Airworthiness Directive Schedule

Aeroplanes

Piper PA-34 Series (Seneca I, II, III, IV and V)

28 February 2013

Figure 1

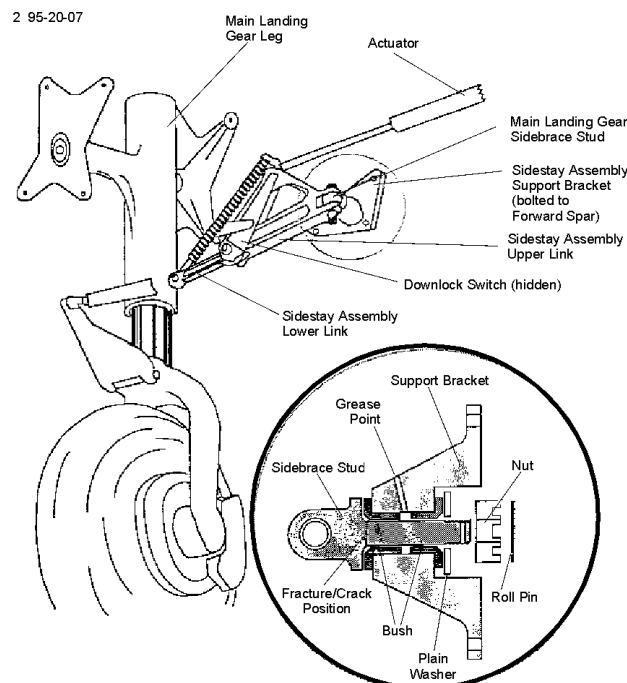
Requirement: To prevent main landing gear (MLG) collapse due to possible main gear sidebrace stud cracks which if not detected and corrected could result in loss of aircraft control during landing, accomplish the following:

Remove both the left and right main gear sidebrace studs from the aircraft per the instructions in the landing gear section of the aircraft MM. Inspect both the main gear sidebrace stud for cracks using Type I (fluorescent) liquid penetrant or magnetic particle inspection methods. Figure 1 of this AD depicts the area where the sidebrace stud is to be inspected.

Note: This figure is provided to depict the area of the sidebrace stud to be inspected. This is not intended to represent the configuration of all models affected.

For any main gear sidebrace stud not found cracked, before to further flight reinstall the stud per the instructions in the Landing Gear section of the applicable MM, and reinspect and replace (as necessary) per this AD.

For any main gear sidebrace stud found cracked, before to further flight replace the cracked stud with a serviceable part per the instructions in the Landing Gear section of the applicable MM and accomplish one of the following, as applicable:

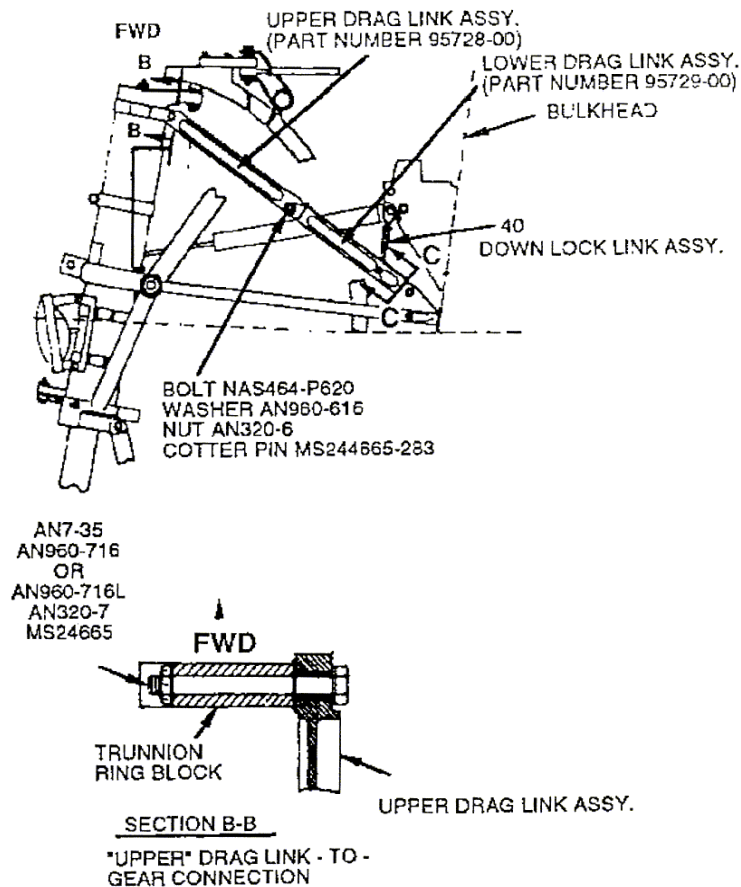
2. Inspect the NLG installation per the instructions in table 1 of Piper SB No. 1123B dated 20 April 2006.

If any defects are found accomplish all the required corrective actions in table 1 of SB No. 1123B before further flight.

Note 2: Paragraph 2 in SB No. 1123B specifies modified parts that may be fitted to improve service life.
